3. COA-049226-2019

2230 Venable Street

Commission of Architectural Review

STAFF REPORT

Figure 1. Figure B, Illustration of a Simulated Divided Lite.

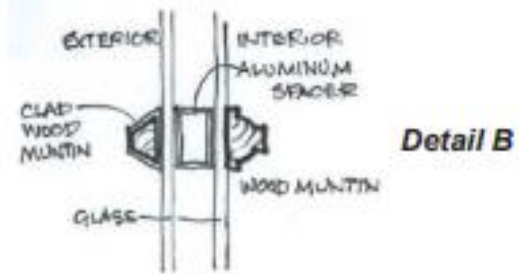
Detail B shows a method for simulating the look of individual panes of glass in a multi-pane window. A decorative bar is applied to both the inside and outside face of the glass, and a spacer bar is placed in between the glass.

Since the applicant intends to simulate the look of a divided light, staff recommends an applied exterior and interior muntin as well as a spacer bar. However, since the windows have already been installed, and this is a large, multi-building development by a nonprofit housing developer, staff recommends a compromise solution to approve the application of exterior muntins only to all windows on the five newly constructed buildings.

- Any additional project changes be coordinated with staff.
